21/00736/FUL

**Haydons Bank
Station Road
Chipping Campden
Gloucestershire
GL55 6HY**

Single storey ancillary accommodation within garden at Haydons Bank Station Road Chipping Campden Gloucestershire GL55 6HY

Full Application 21/00736/FUL	
Applicant:	Mr & Mrs Chatfield
Agent:	Cotswolds Architects Chipping Campden
Case Officer:	Rachel Gaskell
Ward Member(s):	Councillor Mark Annett Councillor Gina Blomefield
Committee Date:	8th September 2021
RECOMMENDATION:	PERMIT

Drawing: Proposed GA Plan
 (Planning Application)
 Drawing No: 158/P03 Rev B
 Scale: 1:100 @ A3
 Date: January 2021

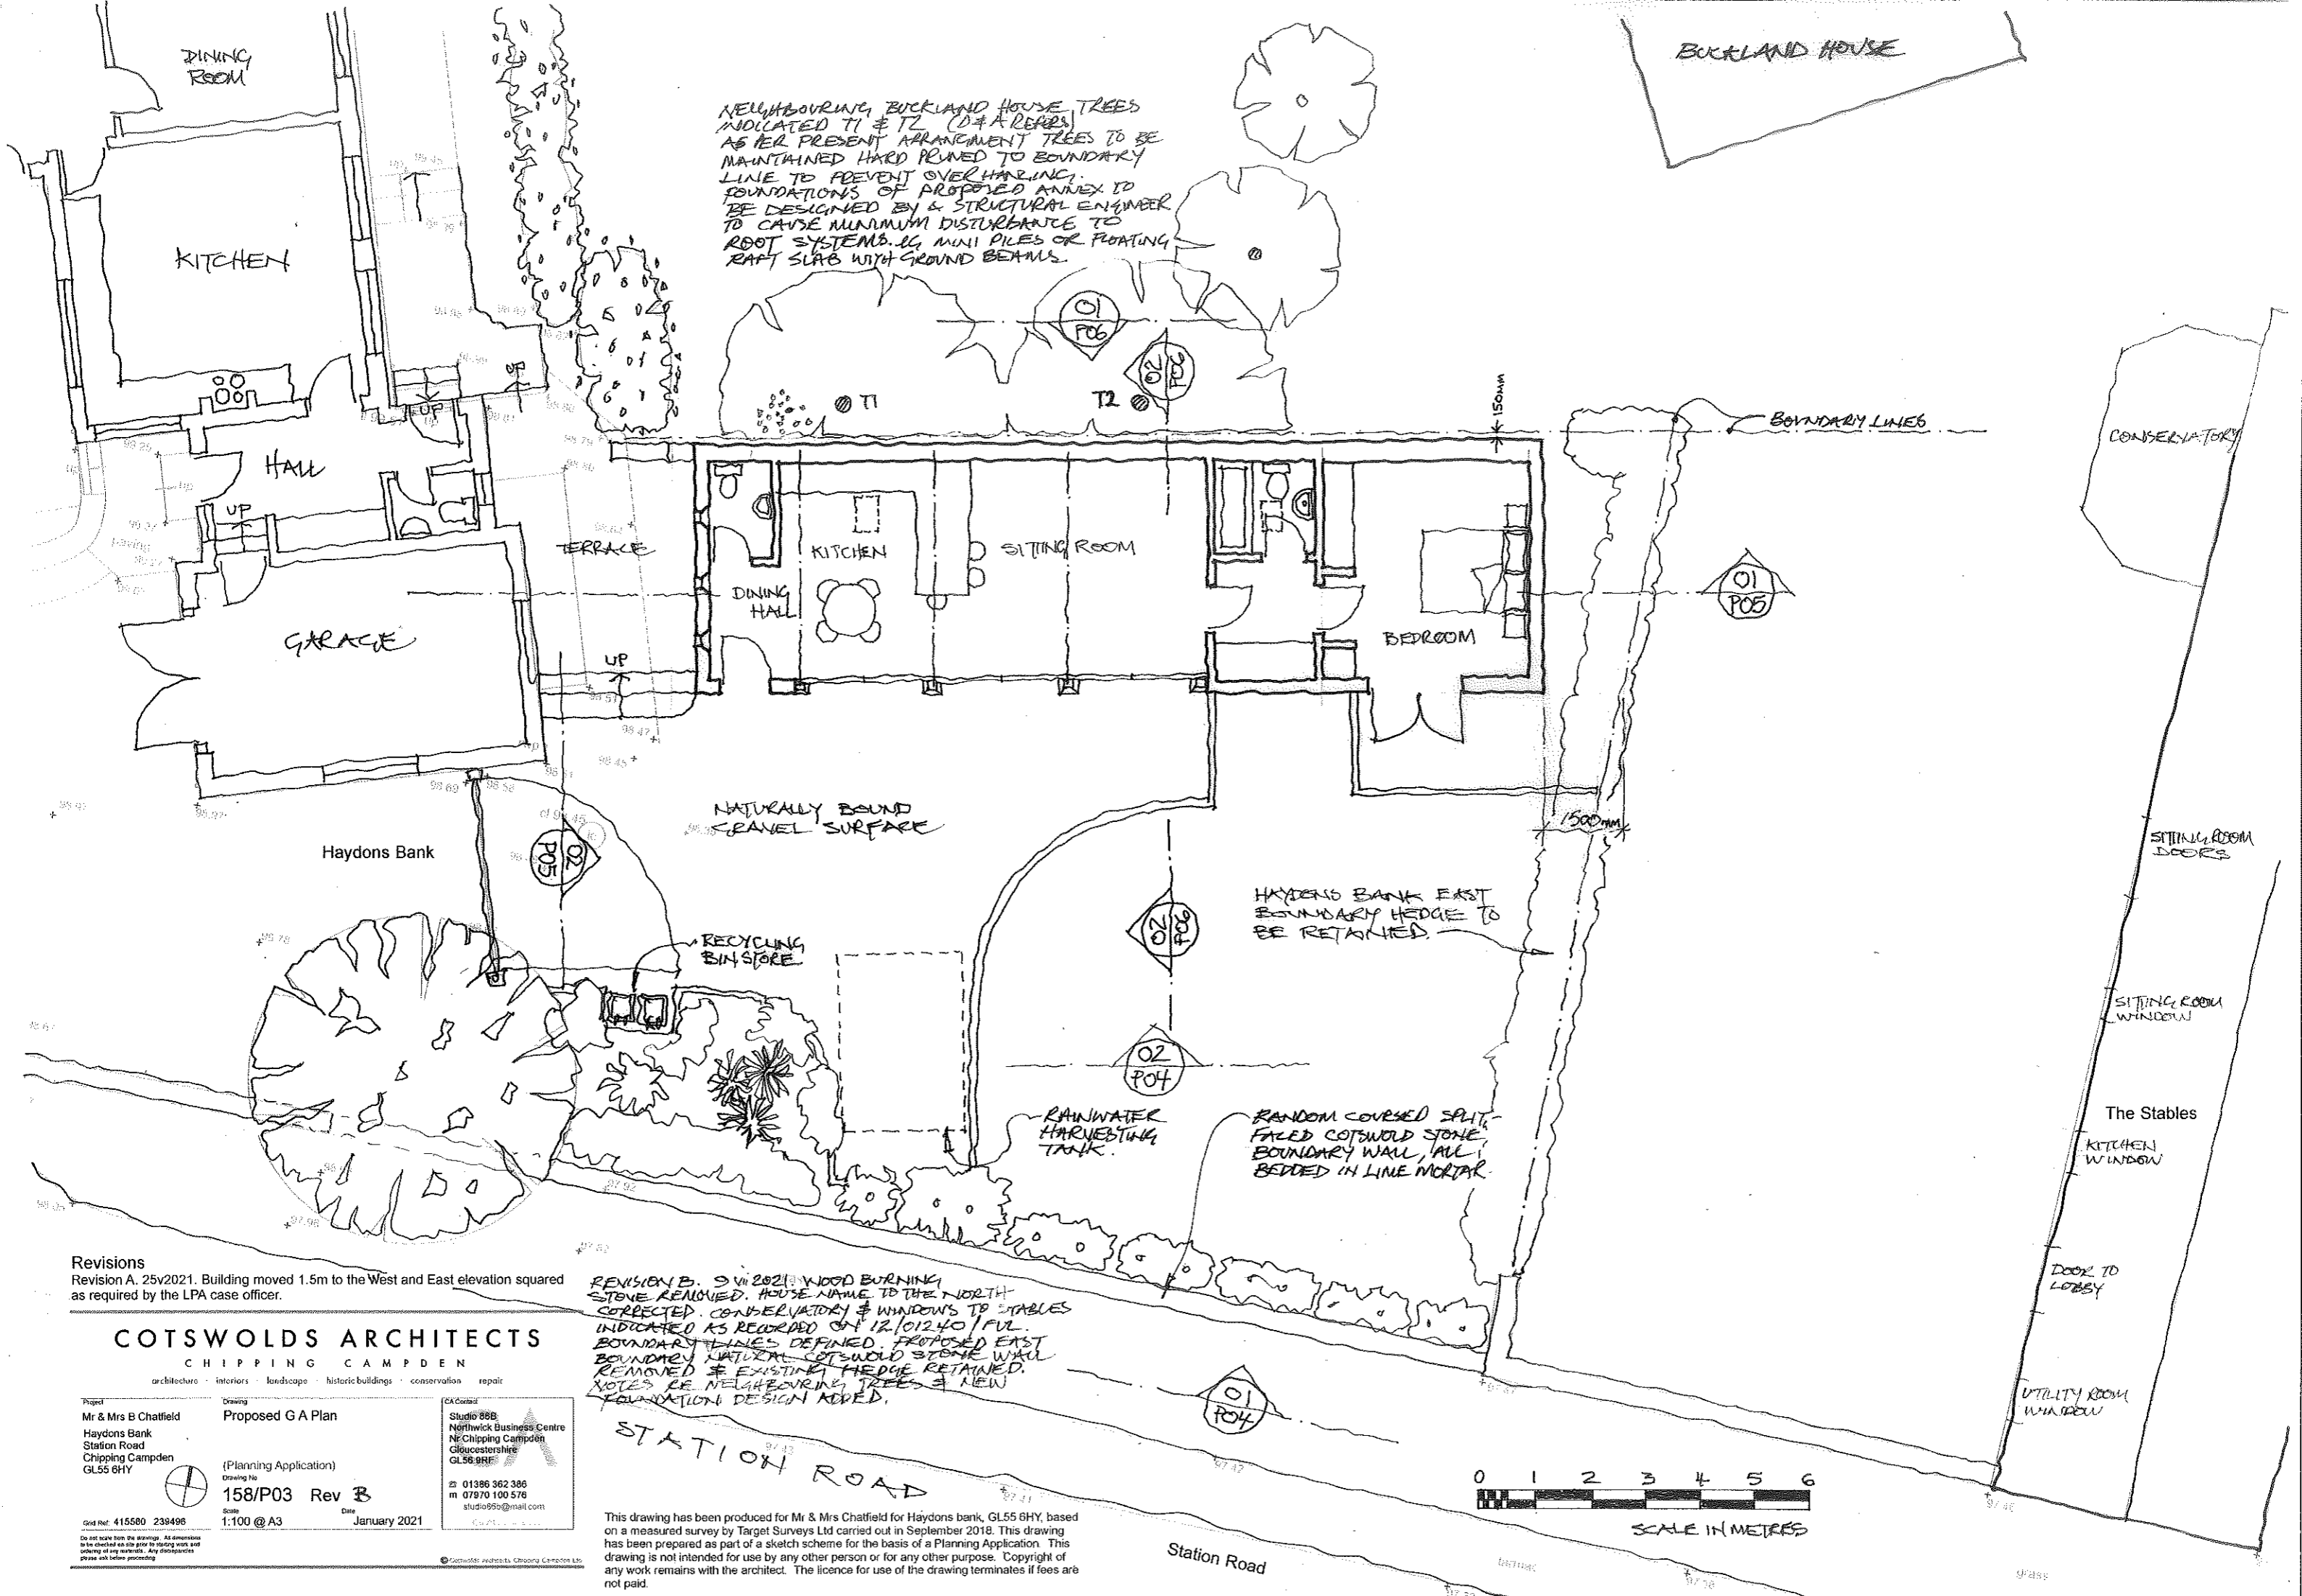
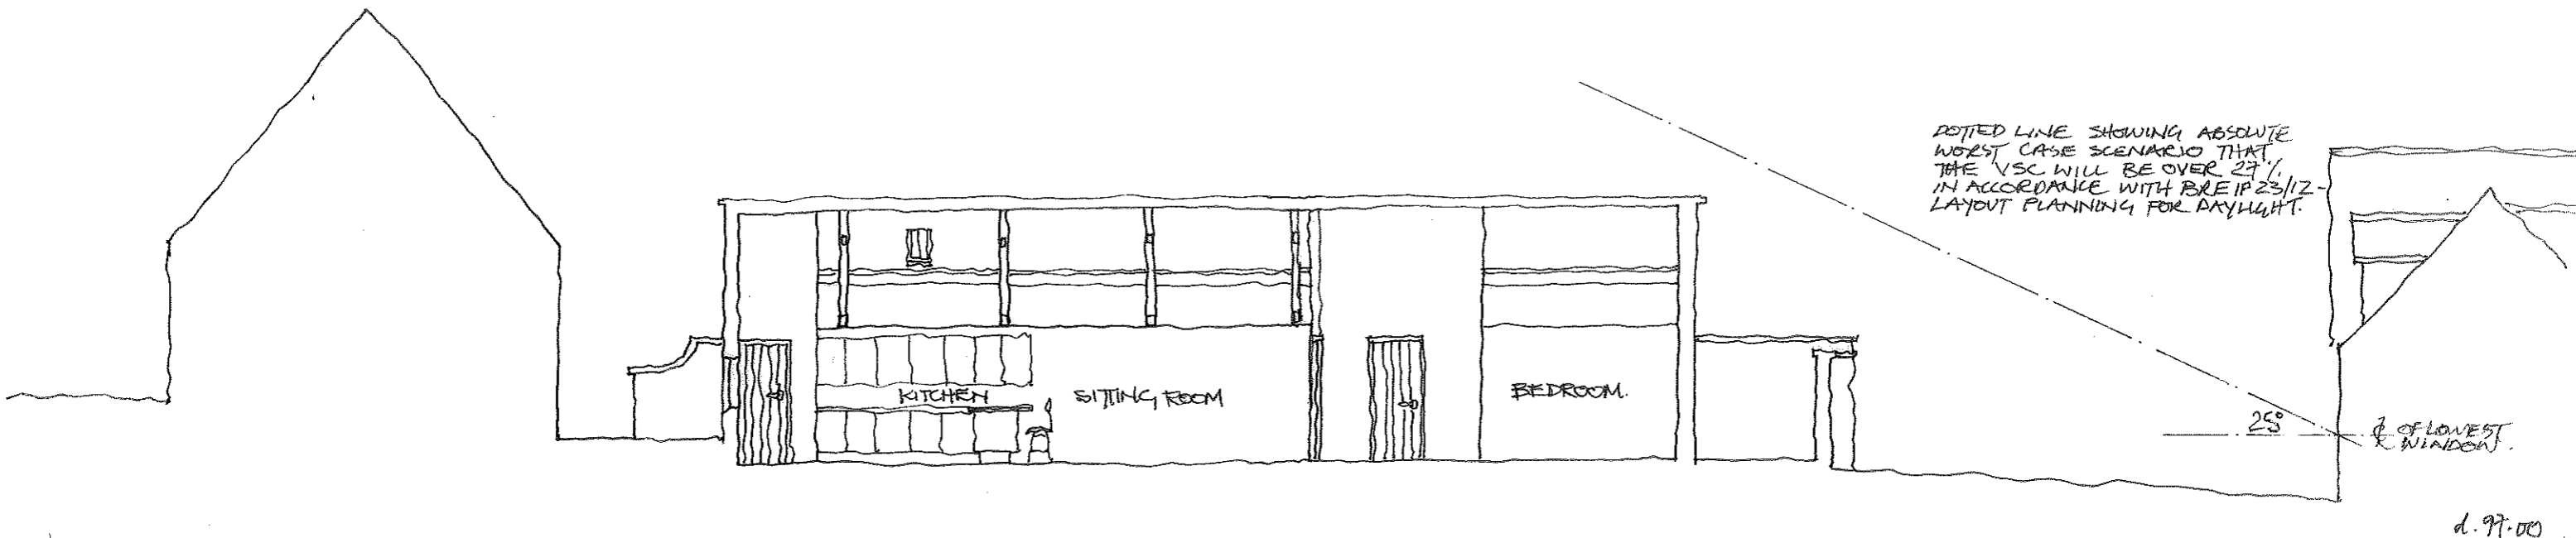
- 8.48 Local Plan Policy EN7 seeks to preserve and enhance trees, hedgerows and woodlands.
- 8.49 The current plans now show the retention of the hedge to the eastern boundary. The existing trees within the neighbouring property to the north (Buckland House) have been

shown on the amended block plan and reference has been made on the plan to these being retained. Further comments have been received from the owner of this property in relation to the impact of the proposal upon these trees, the Council's Tree Officer has advised that: "the trees and hedge in the photos are fairly young and are not considered to be veteran trees or trees, woodlands or hedges of high landscape, amenity, ecological or historical value. As such there no tree policy objection to the development. The potential impact of the development on tree roots would be a civil issue between the properties and we would not require specialist foundation design to protect tree roots."

NEIGHBOURING BUCKLAND HOUSE TREES INDICATED T1 & T2 (D&A RECORDS) AS PER PRESENT ARRANGEMENT TREES TO BE MAINTAINED HARD PRUNED TO BOUNDARY LINE TO PREVENT OVERHANGING. FOUNDATIONS OF PROPOSED ANNEX TO BE DESIGNED BY A STRUCTURAL ENGINEER TO CAUSE MINIMUM DISTURBANCE TO ROOT SYSTEMS. EG MINI PILES OR FLOATING RAFT SLAB WITH GROUND BEAMS.

REVISION B. 9/1/2021. WOOD BURNING STONE REMOVED. HOUSE NAME TO THE NORTH CORRECTED. CONSERVATORY & WINDOWS TO STABLES INDICATED AS REQUIRED ON 12/10/2020 / PUL. BOUNDARY LINES DEFINED. PROPOSED EAST BOUNDARY NATURAL COTSWOLD STONE WALL REMOVED & EXISTING HEDGE RETAINED. NOTES RE NEIGHBOURING TREES & NEW FOUNDATION DESIGN ADDED.

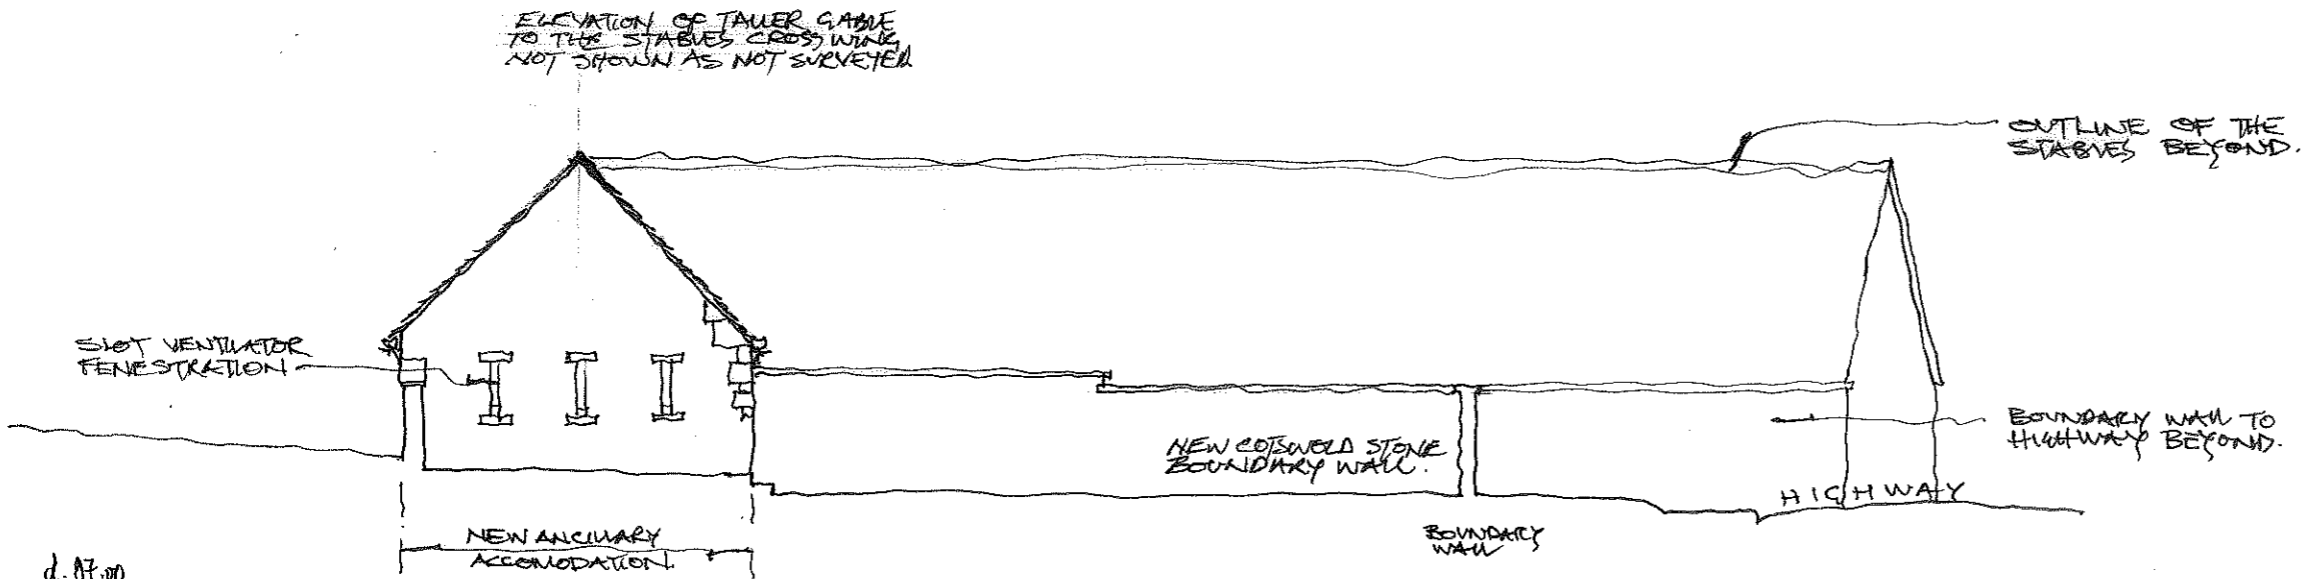
- i) The line of 25 degrees from The Stables is incorrect as the conservatory is the main habitable room. If drawn correctly it would impinge on light to this property.

2. The requirement for details relating to BRE IP 23/12 have not been met. The 25 degree measurement is from the rear of The Stables wall and not from The Stables Conservatory and takes no account of the change in . There are also no details with regard to the impact on the habitable rooms of Buckland House.

2. Details relating to BRE IP 23/12 were agreed with the case officer and met by our annotating the drawings. The worst case scenario was indicated using the apex of the proposed annex as a reference point to the habitable rooms of The Stables. There will be no loss of daylight from the conservatory of the neighbour of Mr Leighton. Habitable rooms of Buckland House will not suffer loss of daylight as the eaves height to the north elevation of the proposals is too low to have an effect and the roof slopes away from the eaves/boundary.

DOTTED LINE SHOWING ABSOLUTE WORST CASE SCENARIO THAT THE VSC WILL BE OVER 25% IN ACCORDANCE WITH BRE IP 23/12 - LAYOUT PLANNING FOR DAYLIGHT.

REVISION B. 9/11/2021. LINE ADDED DEMONSTRATING THAT THE PROPOSALS DO NOT AFFECT DAYLIGHT TO THE STABLES IN ACCORDANCE WITH BRE IP 23/12 - LAYOUT PLANNING FOR DAYLIGHTING. WOOD BURNING STONE REMOVED.
